The Commission has issued the enclosed Amendments Nos. 65, 65 and 62 for Licenses Nos. DPR-38, DPR-47 and DPR-55 for the Oconee Nuclear Station, Units Nos. 1, 2 and 3. These amendments consist of changes to the Station's common Technical Specifications and are in response to your requests dated April 20, 1978 and June 26, 1978, as supplemented April 27, August 21 and 28, September 6, 22 and 26, 1978.

These amendments revise the Technical Specifications to support the operation of Oconee Unit No. 1 at full rated power during Cycle 5 after core reload, removal of the orifice rod assemblies from the core, and High Pressure Injection Pump operability and operating procedure requirements in the unlikely event of a small break loss-of-coolant accident. By letter dated October 19, 1978, you reported that two steam generator tube plugs were unaccounted for and should be assumed to be in the primary coolant system. Your letter included a safety analysis of this concern. We reviewed your submittal and Appendix A to our enclosed Safety Evaluation represents our evaluation of the safety consequences of these two plugs.

ATTACHMENTS TO LICENSE AMENDMEN

Revise Appendix A as follows:

Figure 2.1-2A

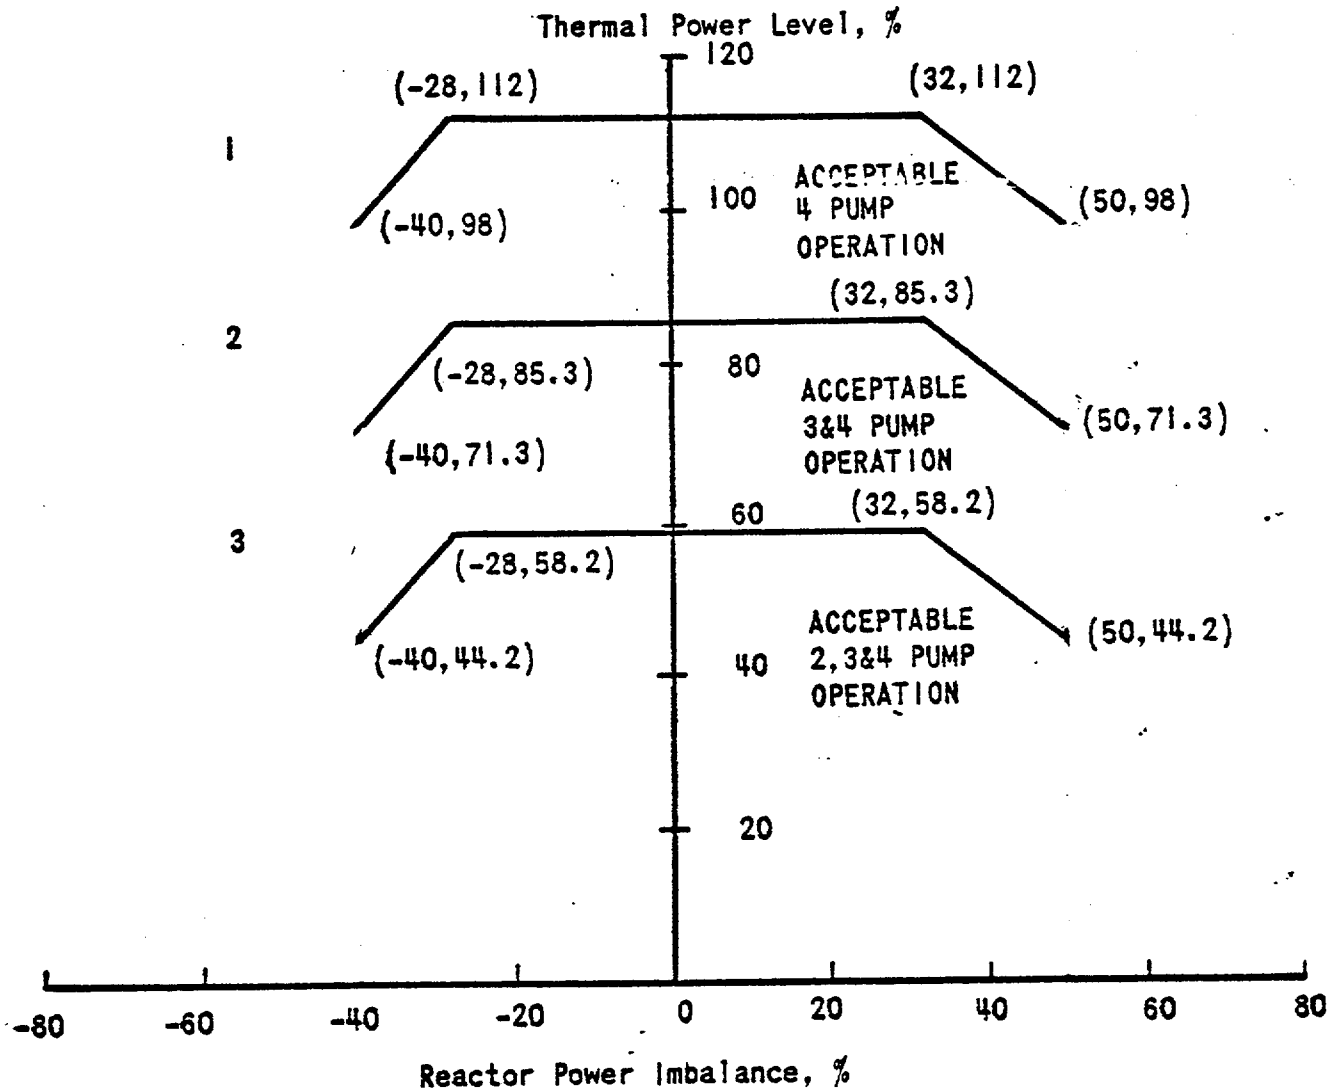
The curves of Figure 2.1-2A are based on the more restrictive of two thermal limits and include the effects of potential fuel densification and rod bowing:

The specified flow rates for Curves 1, 2, and 3 of Figure 2.1-2A correspond to the expected minimum flow rates with four pumps, three pumps, and one pump in each loop, respectively.

Figure 2.1-3A

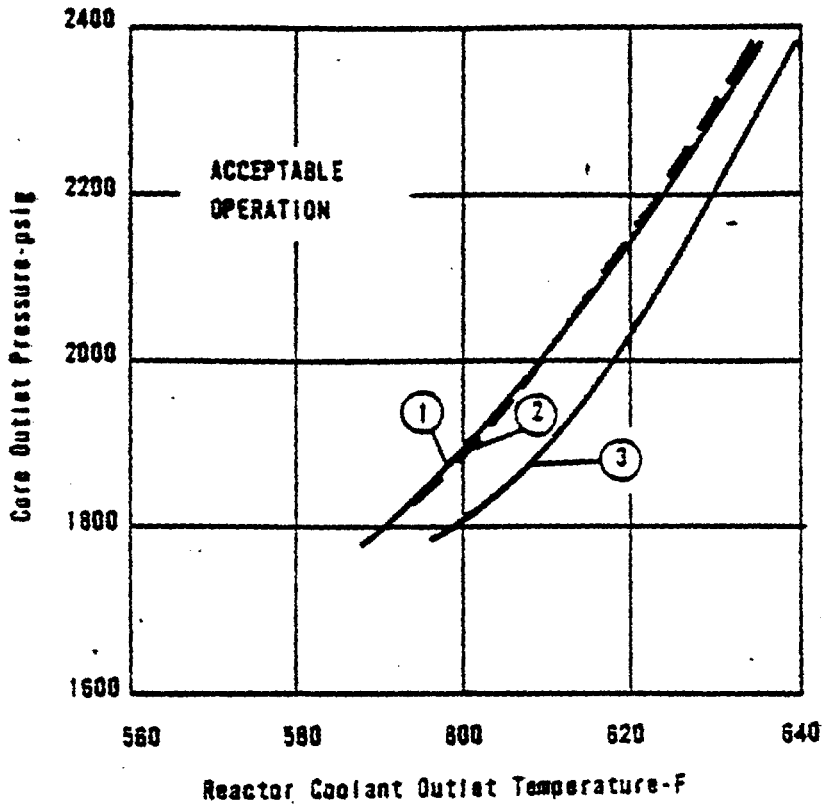
The curve of Figure 2.1-1A is the most restrictive of all possible reactor coolant pump-maximum thermal power combinations shown in Figure 2.1-3A.

Figure 2.3-2A

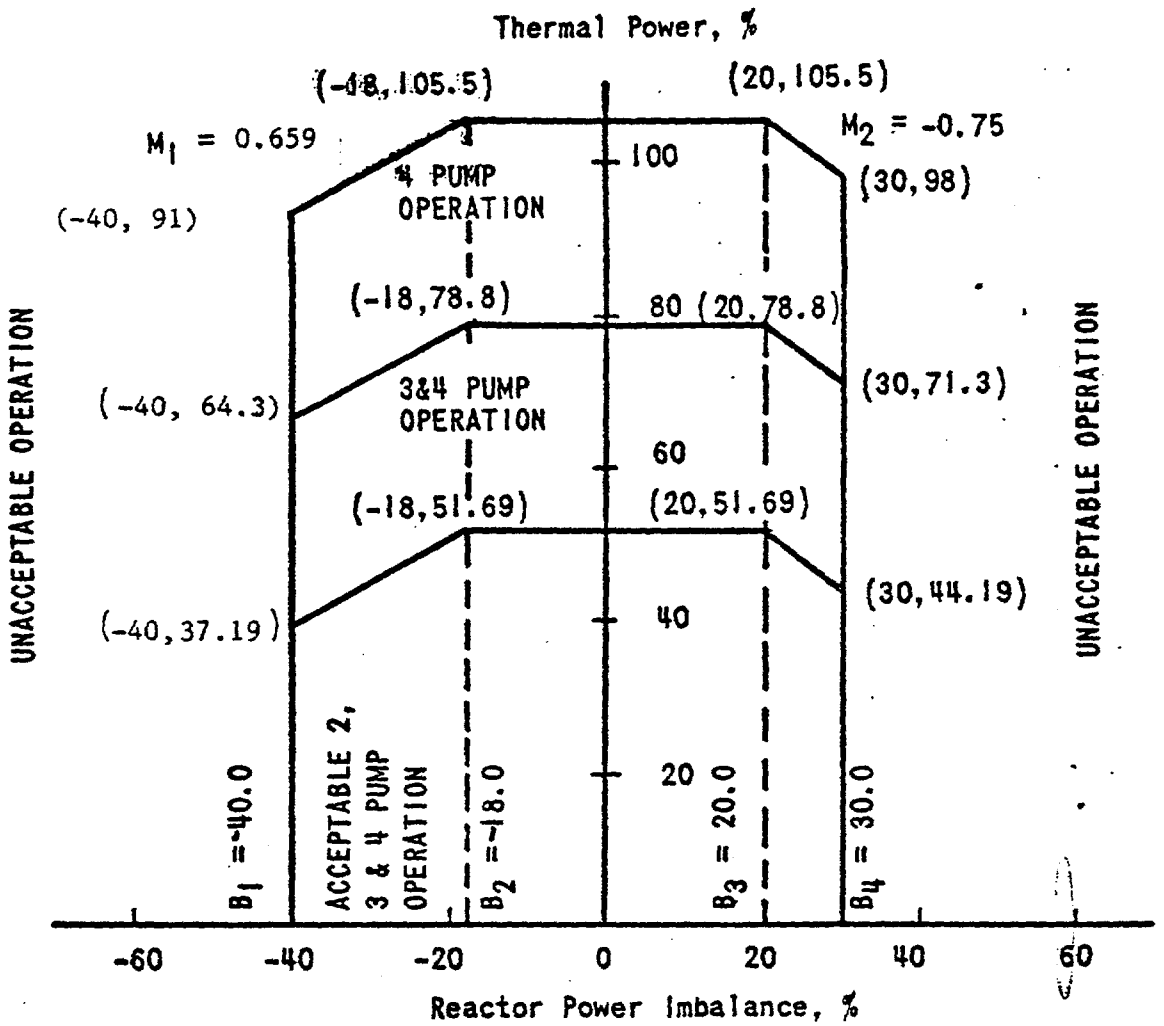
1) Revise the protective system maximum allowable setpoint contained in Specifications 2.1 and 2.3 respectively.

We have reviewed the proposed changes to the Technical Specifications and find them acceptable. These consist of all the changes requested by the licensee in his letter of June 26, 1978(1), except for Figure 2.3-2A which was acceptably revised in the supplement of September 6, 1978(3), and the submittal of April 20, 1978(13), as supplemented April 27, 1978(14), which provides both for timely operator action and maintenance of all the High Pressure Injection pumps in an operable condition in the unlikely event of a small break LOCA during plant operation. The TS for the Oconee Nuclear Station, in terms of radioactivity in the primary coolant and radioactivity releases from the station need not be revised for the five batch 4D Mark B3 demonstration fuel assemblies. These TS are based on a 44,000 MWD/MTU burnup, while the demonstration assemblies will experience only about 41,000 MWD/MTU burnup.

Figure 3.5.2-1A1

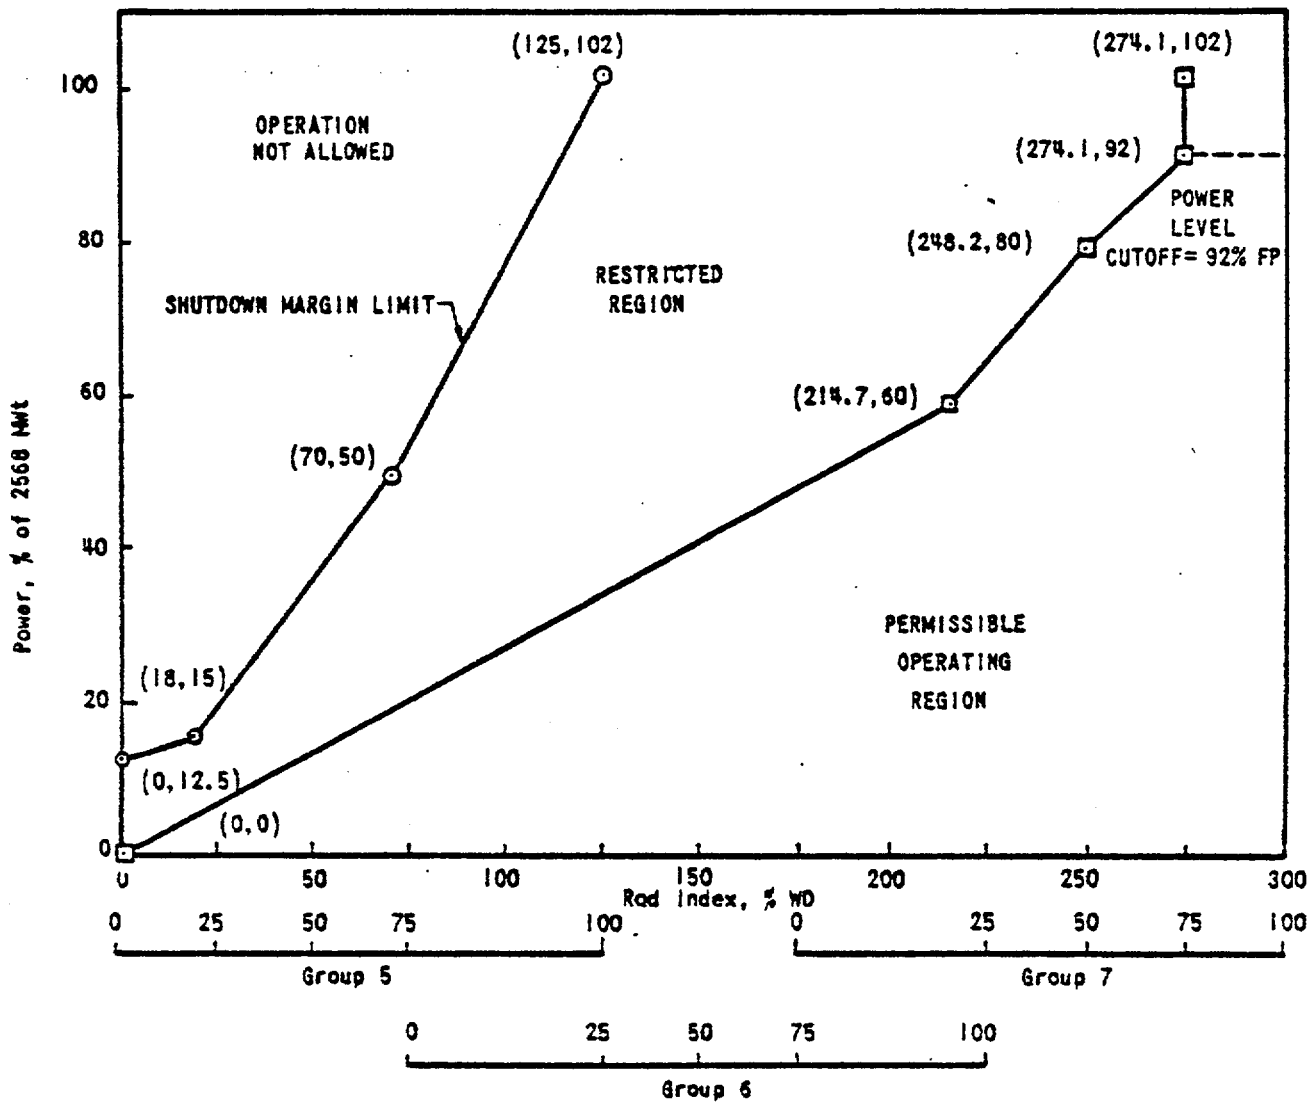
a. Except for physics tests, reactor power in Unit 1 shall not be increased above the power-level-cutoff shown in Figures 3.5.2-1A1, and 3.5.2-1A2 unless one of the following conditions is satisfied:

4) Change Specification Figures 3.5.2-1A1, 3.5.2-1A2, 3.5.2-2A1, 3.5.2-2A2, Rod Position Limits, Figures 3.5.2-3A1, 3.5.2-3A2, Power Imbalance Limits, and Figures 3.5.2-4A1, 3.5.2-4A2, Axial Power Shaping Rod (APSR) Position Limits.

Figure 3.5.2-3A1

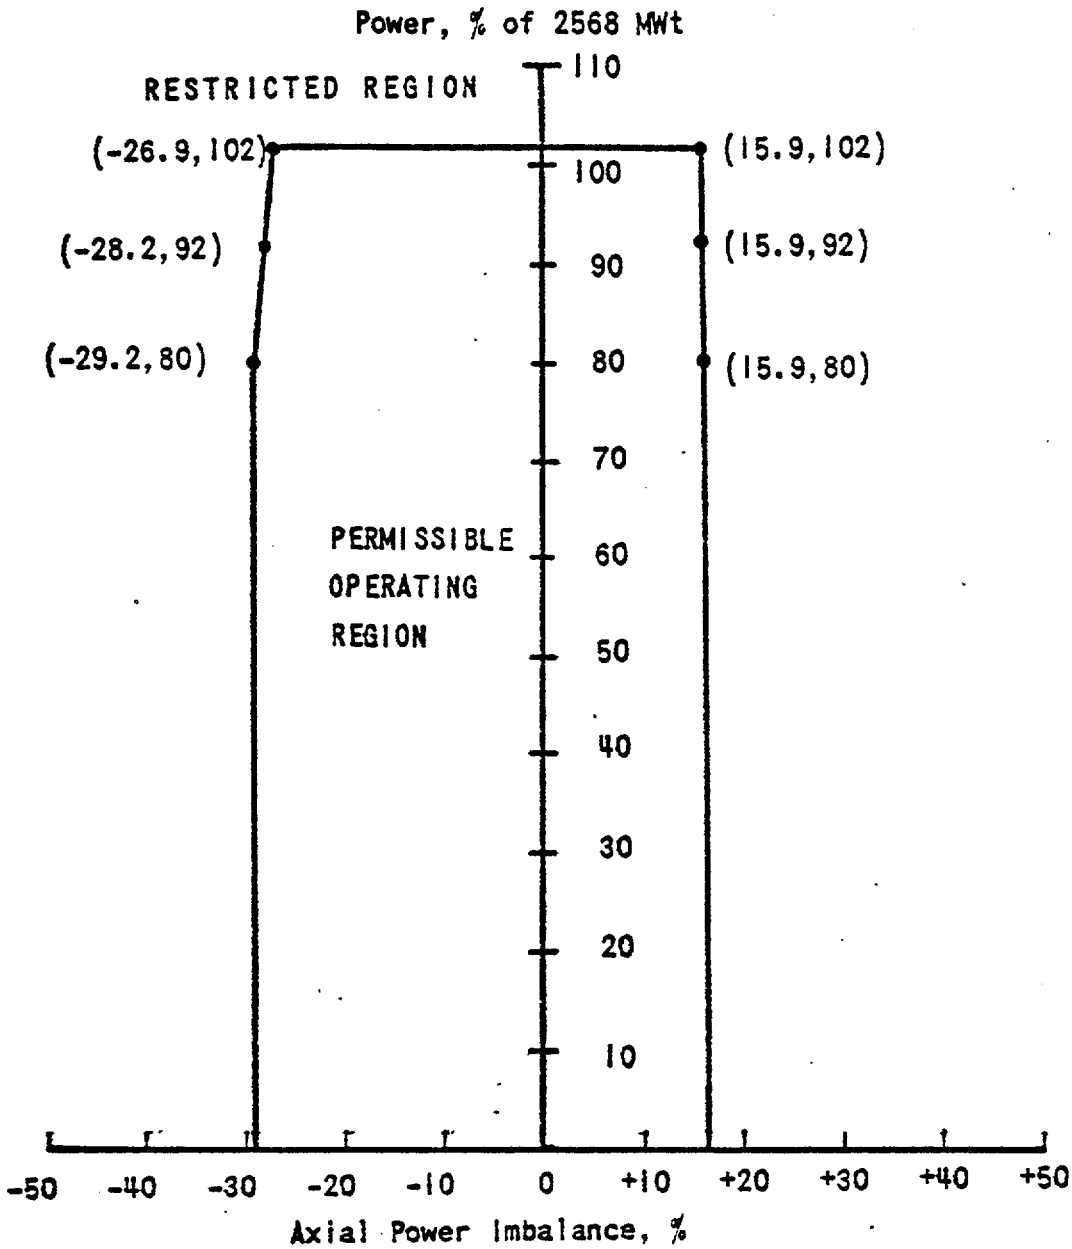
The power-imbalance envelope defined in Figures 3.5.2-3A1, 3.5.2-3A2, 3.5.2-3B1, 3.5.2-3B2, 3.5.2-3B3, 3.5.2-3C1, 3.5.2-3C2 and 3.5.2-3C3 is based on LOCA analyses which have defined the maximum linear heat rate (see Figure 3.5.2-5) such that the maximum clad temperature will not exceed the Final Acceptance Criteria. Corrective measures will be taken immediately should the indicated quadrant tilt, rod position, or imbalance be outside their specified boundary. Operation in a situation that would cause the Final Acceptance Criteria to be approached should a LOCA occur is highly improbable because all of the power distribution parameters (quadrant tilt, rod position, and imbalance) must be at their limits while simultaneously all other engineering and uncertainty factors are also at their limits.** Conservatism is introduced by application of:
